Tender No. 633-2023 Addendum No. 1 Page 2 of 5

Typical new parapet construction.

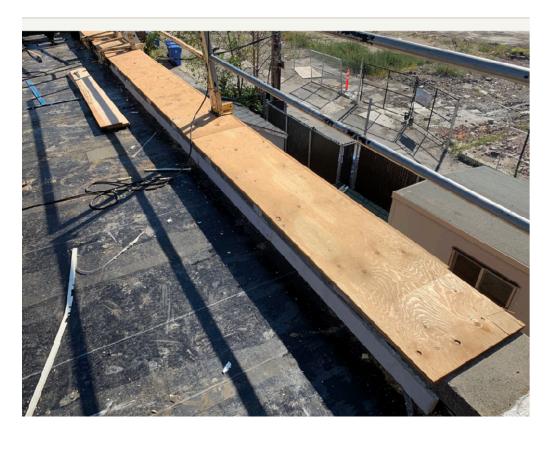
Plywood sheathing to be applied to all roof membrane and flashing mateable surfaces.

Elevations with sufficient parapet clearance roof assembly slope and base insulation to conform. (Will be reviewed in shop drawing submittal process.)
